Agenda for 68th PCCM

Govt. of India
Ministry of Power
North Eastern Regional Power Committee
Shillong

68th Protection Coordination Sub-Committee Meeting

Date: 13/06/2024 (Thursday)

B.9 Grid Disturbance in Monarchak and Rabindranagar S/S of Tripura on 02-May-24:

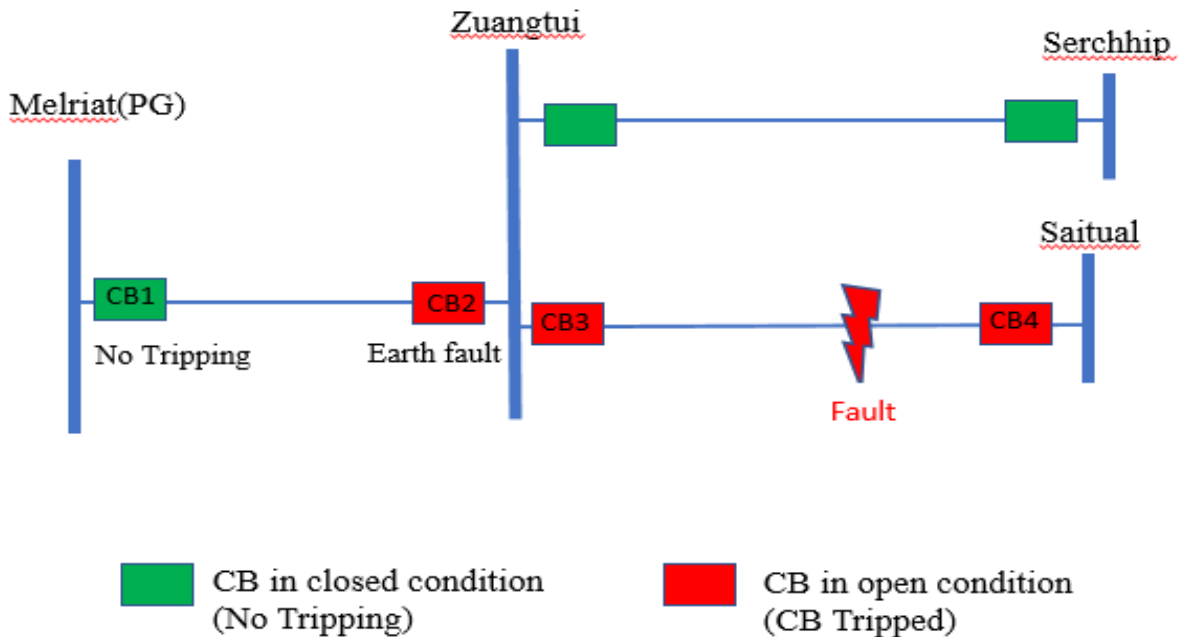
As per DR analysis of 132 kV Monarchak-Udaipur line, B-E fault (Ib-2.4 kA, In-2.6 kA) initiated at 18:32:20.233 Hrs and cleared within 61 msec on operation ZI from Monarchak end. Auto recloser was successful from Udaipur end.

- Huge DR time drift of 10 min at Monarchak and 8 min at Udaipur. Needs to be rectified by NEEPCO and TPTL.
- DR time duration is insufficient at Udaipur. It should be extended to 3 seconds, with a pre-fault time of 500 milliseconds and a post-fault time of 2.5 seconds.
- Flash Report and Detailed report not submitted by NEEPCO & TSECL which is violation of IEGC Section 37.2 (b) & (e).

TSECL/TPTL is requested to share the root cause and remedial measures taken.

B.12 Frequent Grid disturbances in Myntdu Leshka HEP of Meghalaya Power System:

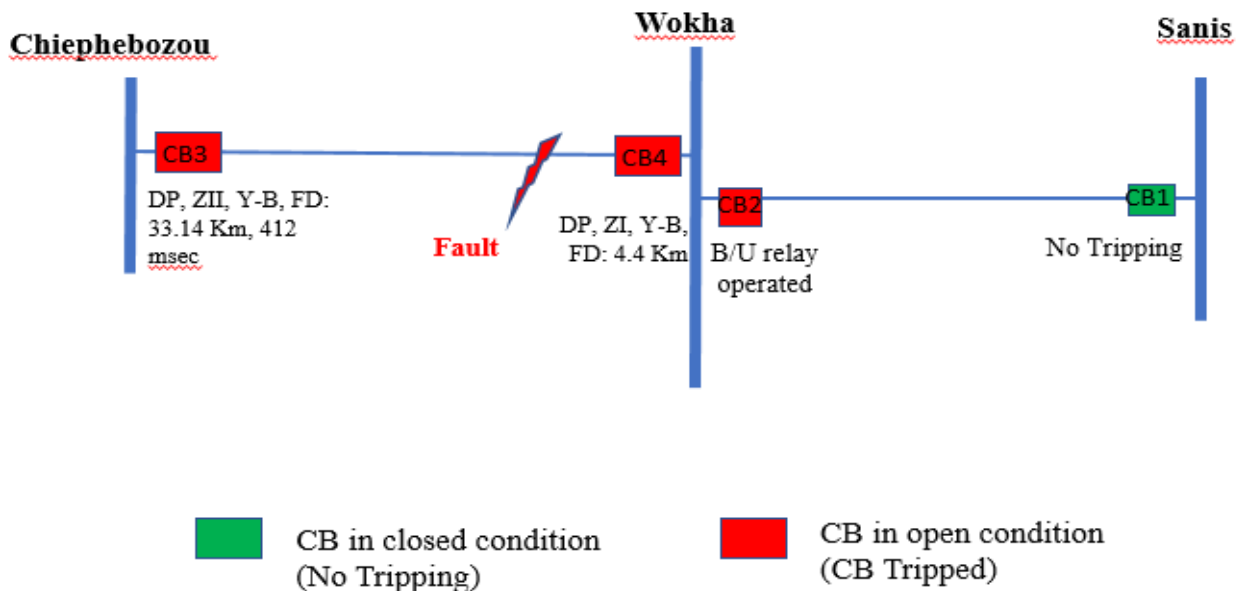
1. There was no Auto reclose attempt observed. The auto-reclose (A/R) scheme should be inspected and activated to ensure the safe evacuation of Leshka generation by reclosing the line in case of single phase fault.
2. ZII time delay need to be reviewed as per NERPC protection philosophy.
3. DR channels needs to be standardized both ends:
 - DR time duration appears to be insufficient at Leshka. It should be extended to 3 seconds, with a pre-fault time of 500 milliseconds and a post-fault time of 2.5 seconds.
 - DR time not synchronised, exhibiting time drift issue at Leshka & Khliehriat.
 - CB status is currently not allocated in the DR digital channel. It's essential for MePTCL and MePGCL to include CB ON/OFF status in DR channels at both ends for fruitful analysis of events.

4. MePGCL is requested to ensure that patrolling related activities are undertaken as per CEA (Grid Standard) Regulation, 2010 on regular basis and measures may be identified and implemented at the earliest so as minimize tripping of these lines.

B.17 Grid Disturbance in Tipaimukh area of Manipur on 17-April-24:

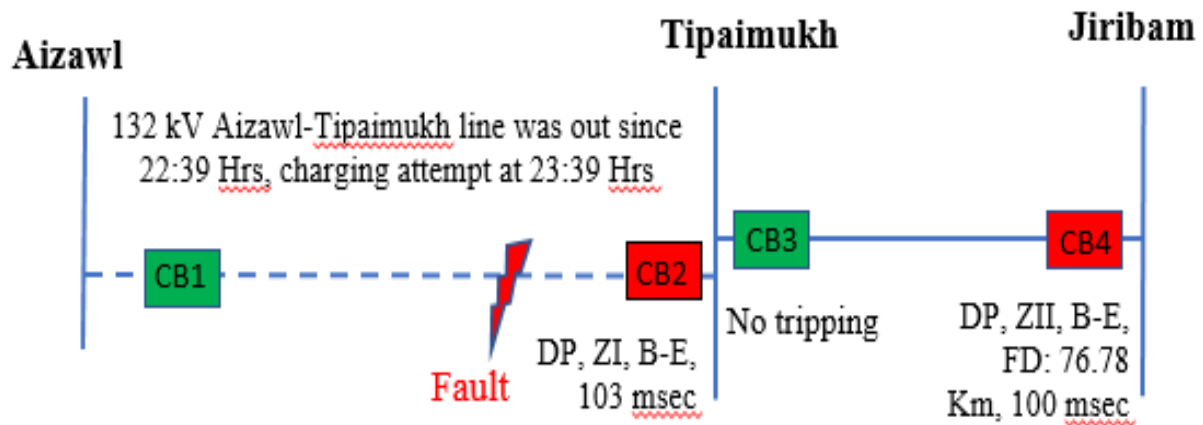
- i) Tripping of healthy 132 kV Jiribam(PG)-Tipaimukh line due to delayed fault clearing at Tipaimukh end (more than 100 msec) for 132 kV Aizawl-Tipaimukh line.
- ii) 132 kV Jiribam-Tipaimukh line tripped from Jiribam end in 100 msec on operation of DP, ZII. ZII time delay setting needs to be reviewed and set as per NER Protection philosophy.

- i) PLCC in 132 kV Jiribam(PG)-Tipaimukh line to be made healthy.
- ii) Delayed fault clearing time by CB (more than 100 msec) at Tipaimukh for Aizawl-Tipaimukh line.

POWERGRID is requested to share the actual root cause of multiple tripping of 132 kV Aizawl-Tipaimukh line.
